SEWAGE DISPOSAL SYSTEM

MARYLAND STATE DEPARTMENT OF HEALTH

SUBDIVISION Simpson Woods ROAD 11902 Simpson Road LOT 2, Section 1

NEW SUN ROOM ADDITION
TO THE RESIDENCE OF
MR & MRS CHARLES H. KYPER

INDICATE NORTH — NAME ADJOINING ROADWAY AS BASE LINE

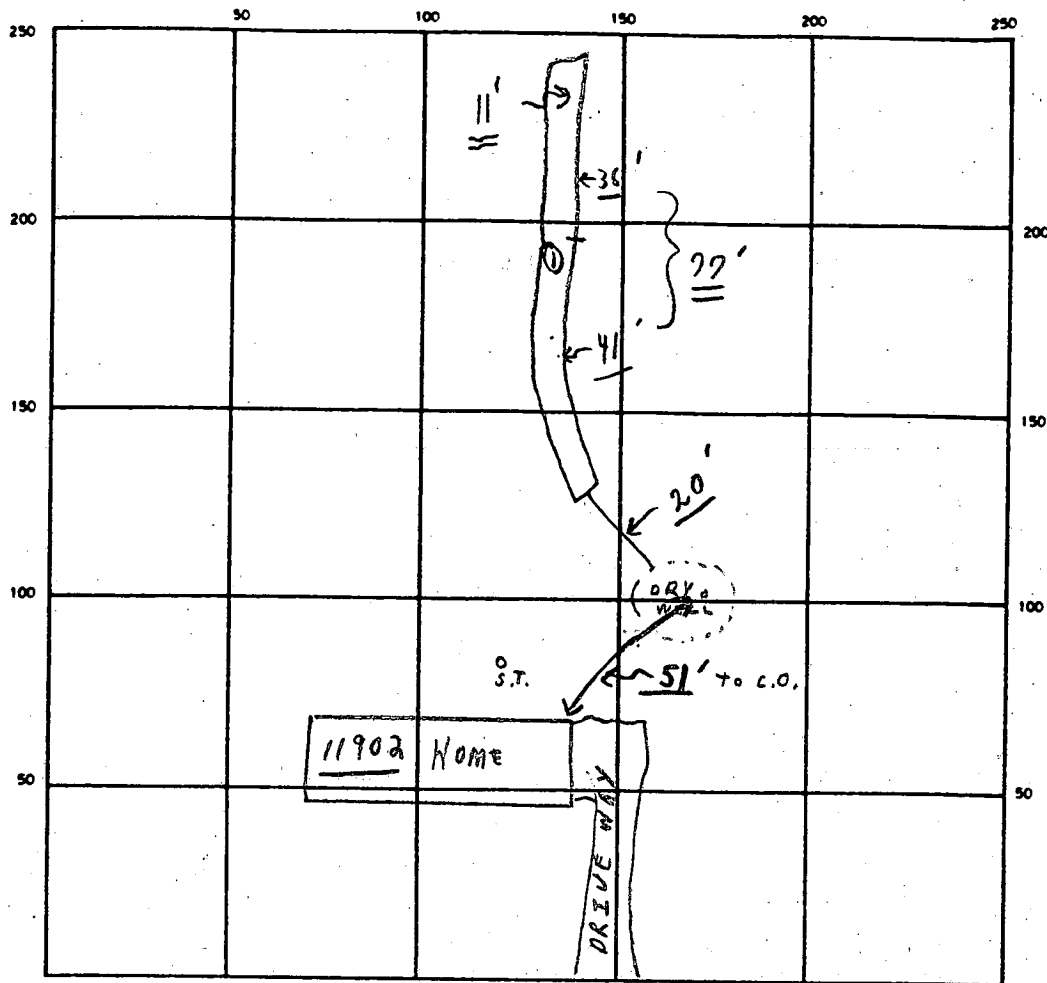
REMARKS A.M. 12/15/88 ① Partial - trench partially dug at rear of property. all water wells 100' from repair.
P.M. ② Trench repair complete. OK TO COVER ALL WORK - FINAL. C.B.D.

INDICATE NORTH. - NAME ADJOINING ROADWAY AS BASE LINE.

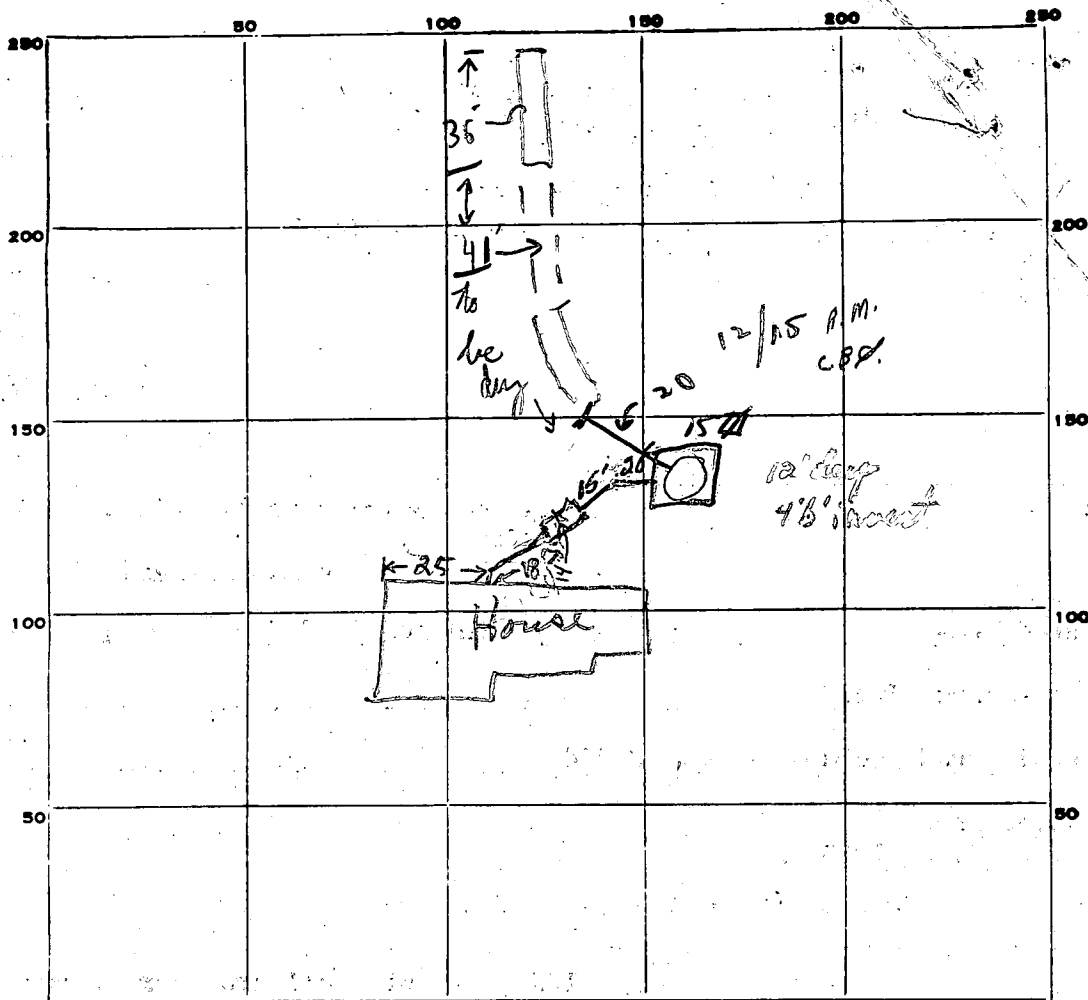
6/13/78 TSO: Add stone to DW. Call For final.
 OK to cover system up to DW.

SITE PLAN
SCALE 1" = 50'

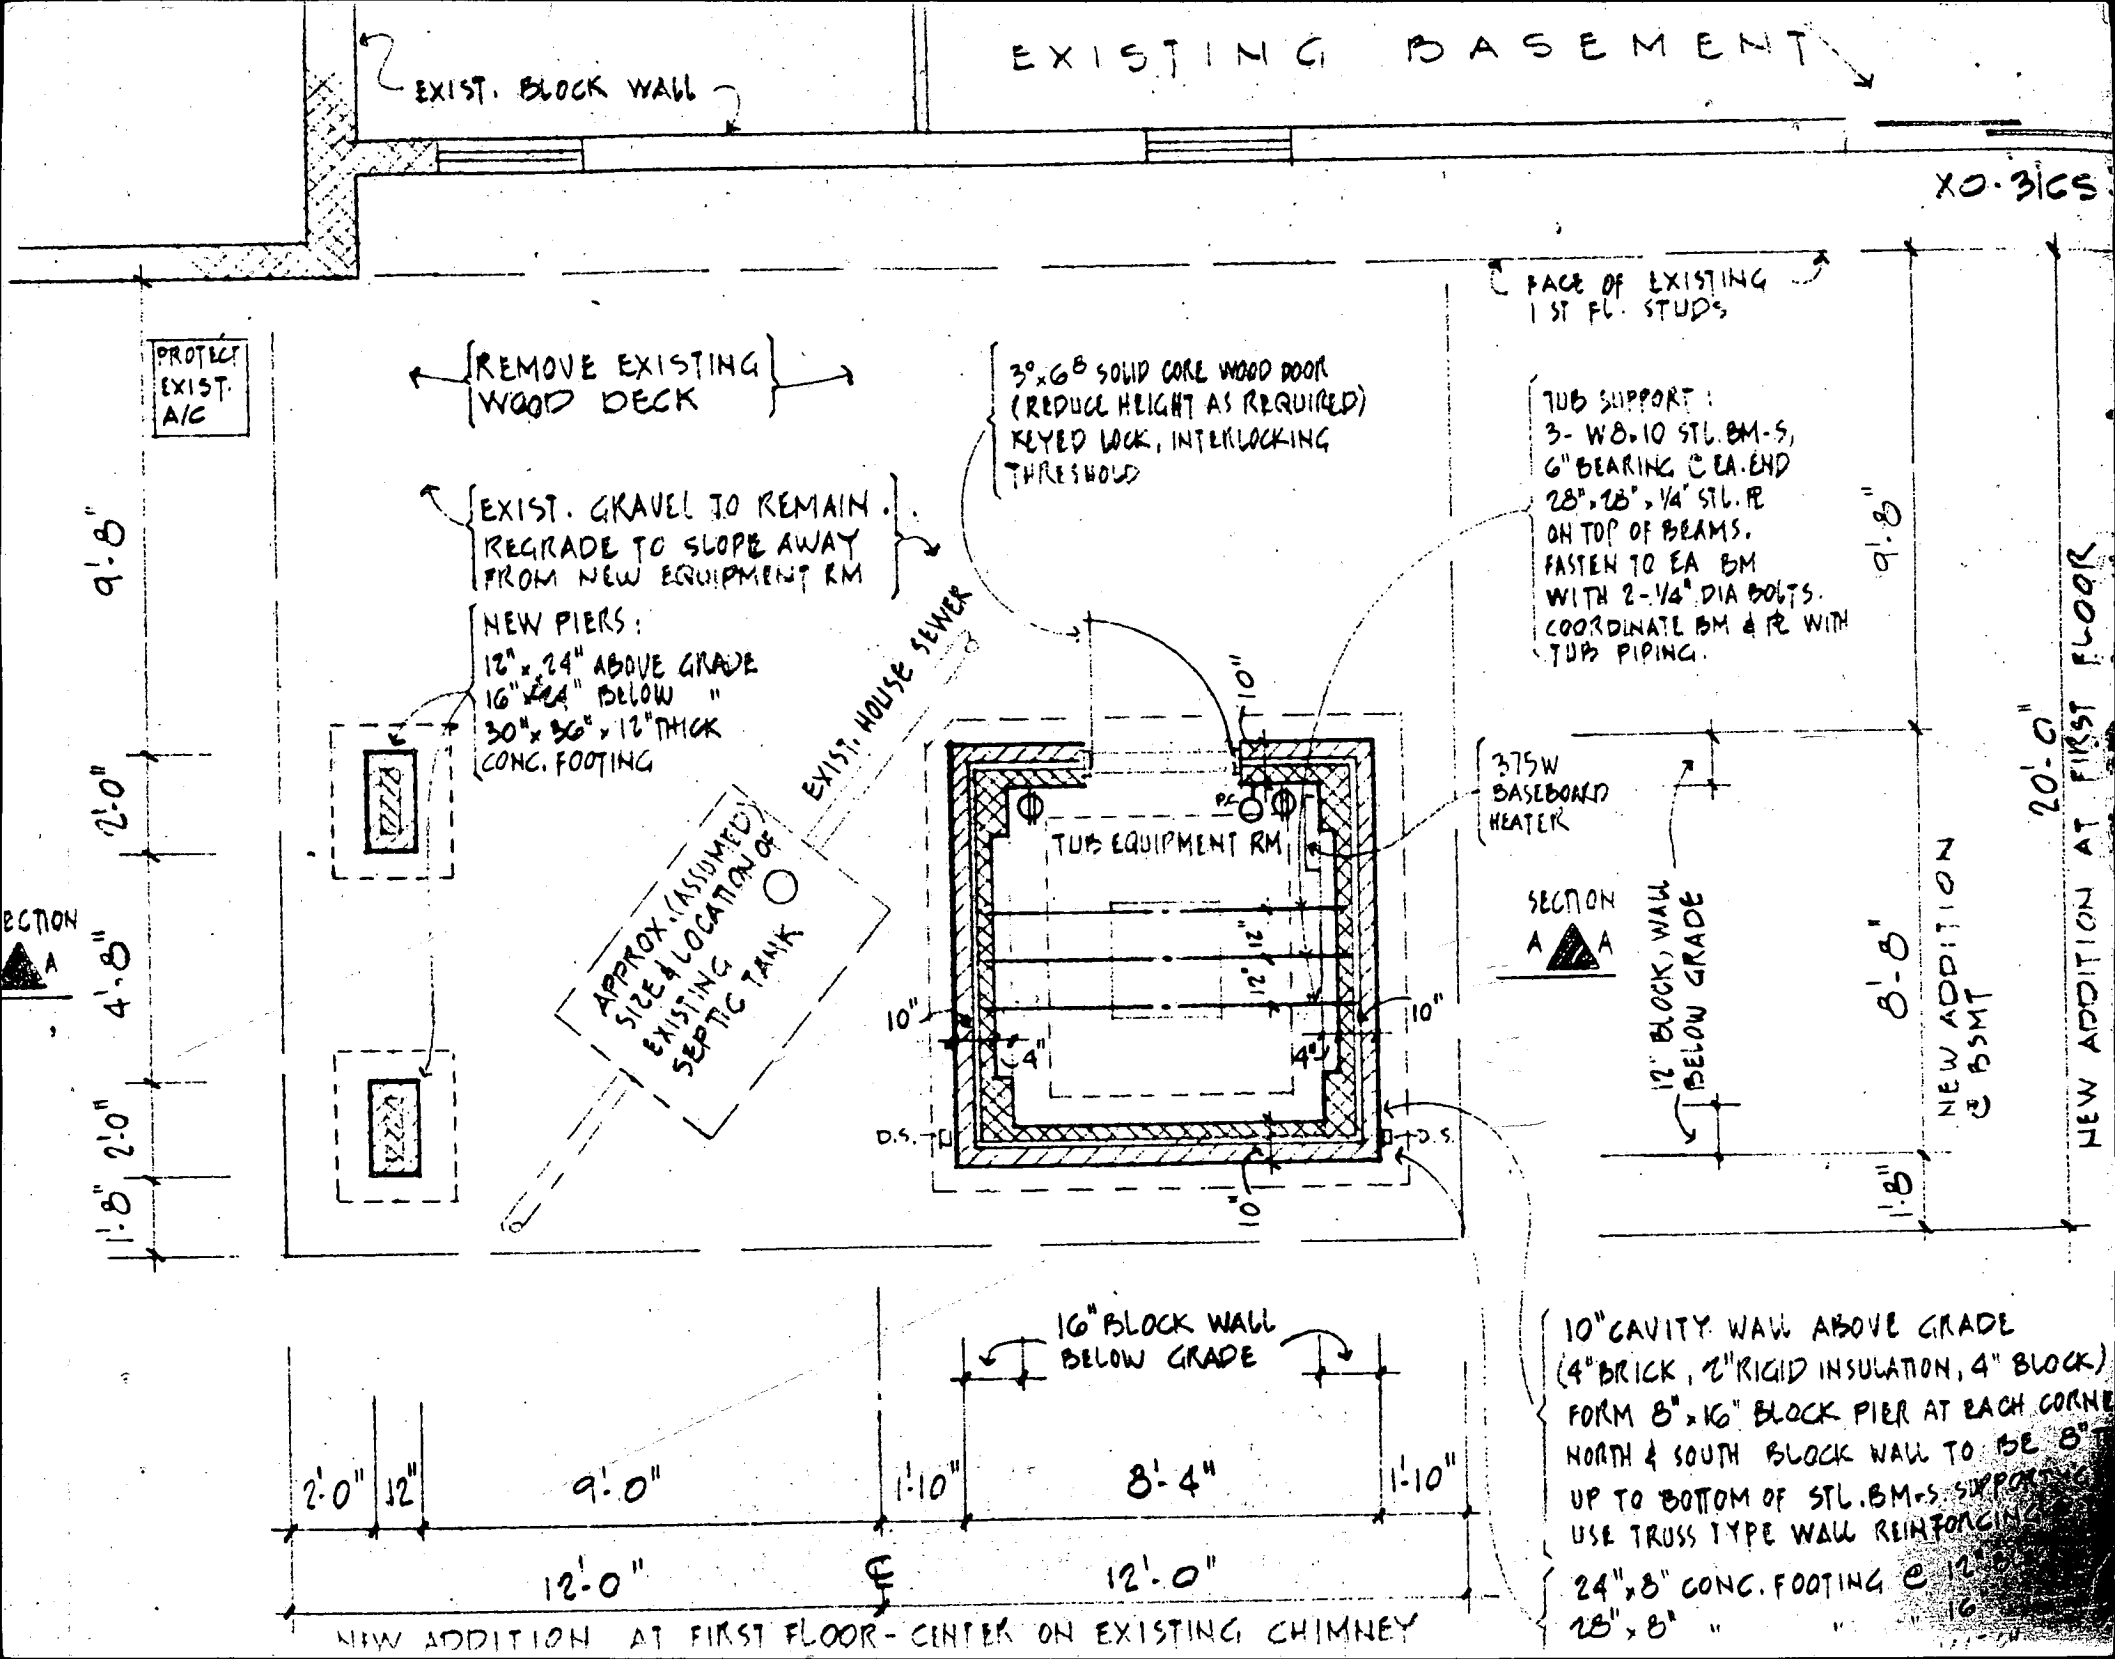
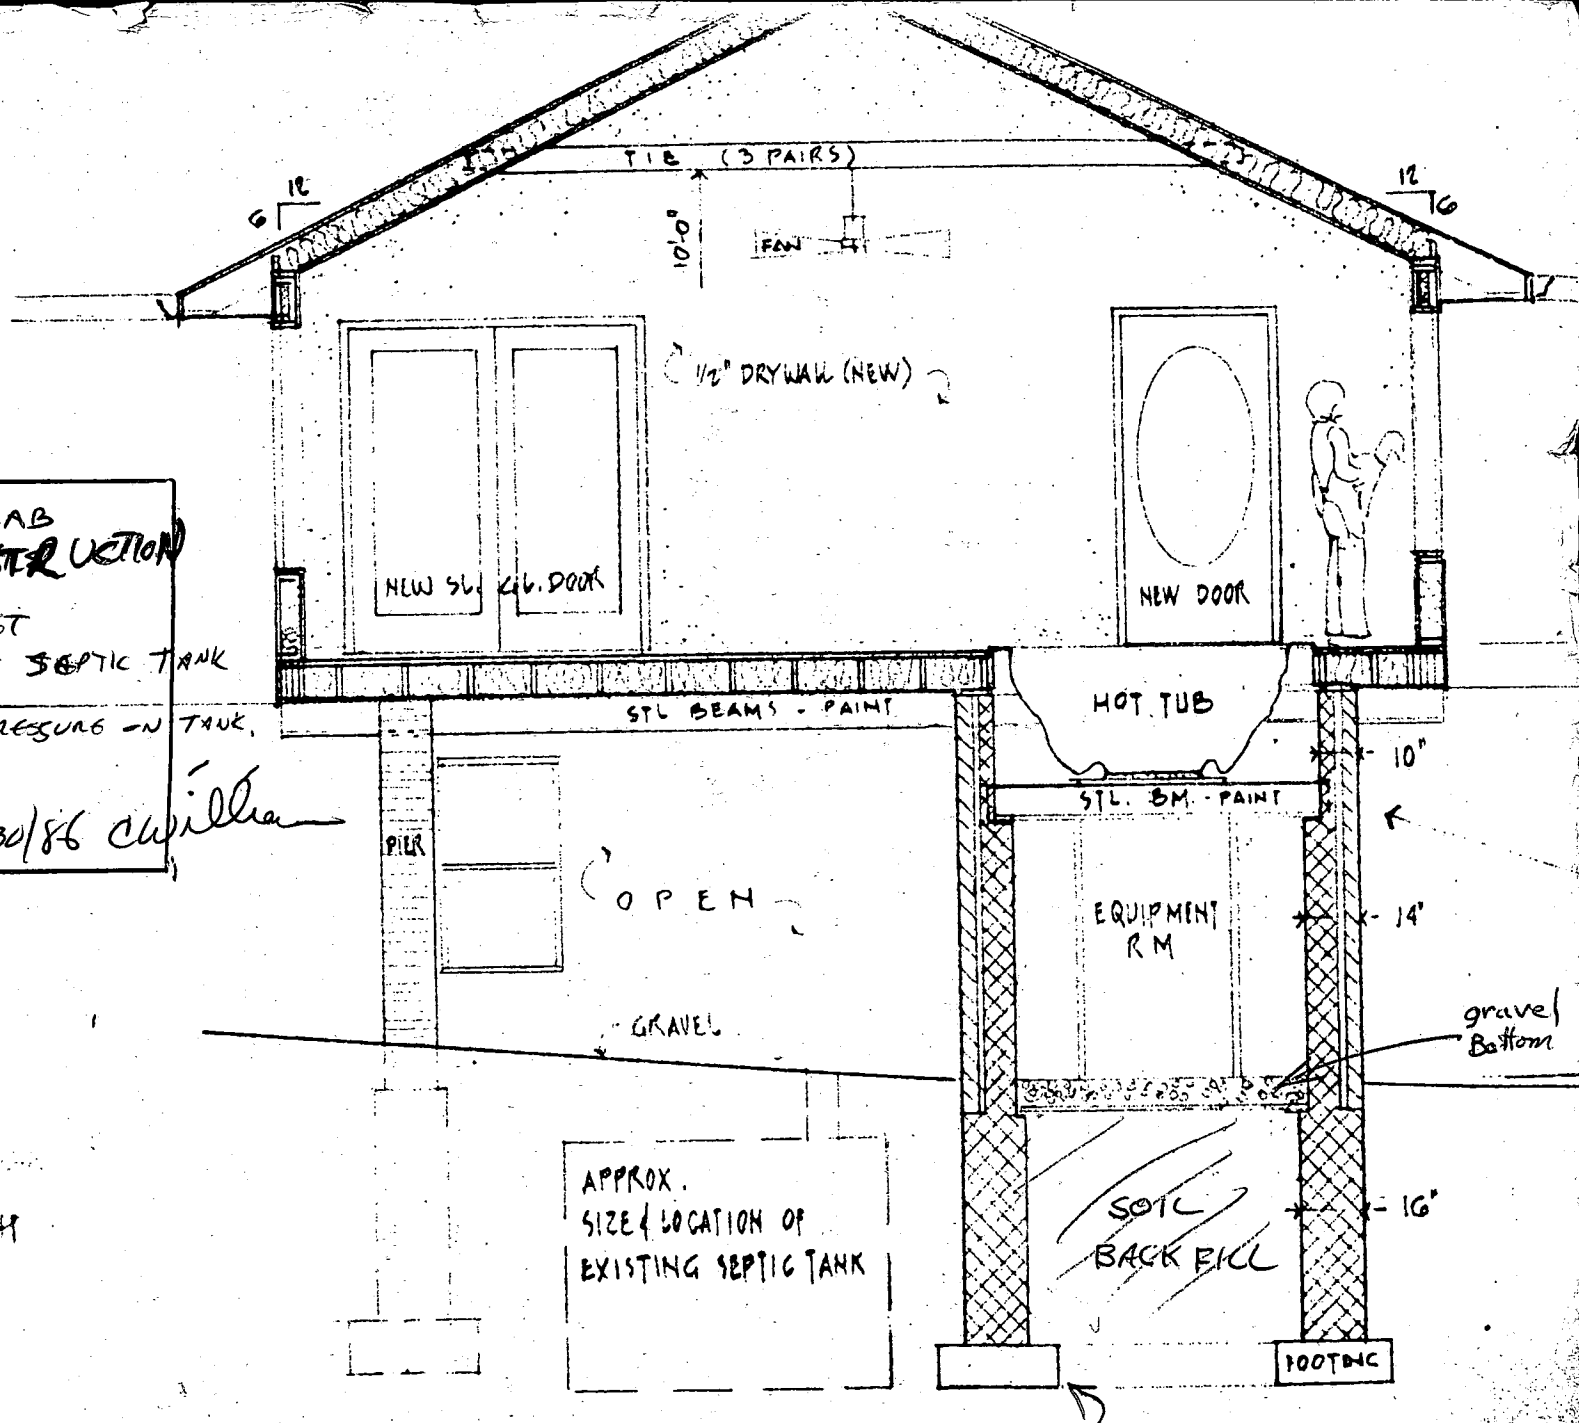
FOOTERS TO BE SET
BELOW BOTTOM OF SEPTIC TANK
TO AVOID SIDE PRESSURE ON TANK.

EXPLANATION: FOOTINGS PLACED AT
A DEPTH OF BOTTOM OF SEPTIC
TANK SO AS TO ELIMINATE ANY
PRESSURE ON S. TANK

OK TO PROCEED
10/30/86 *Chiller*
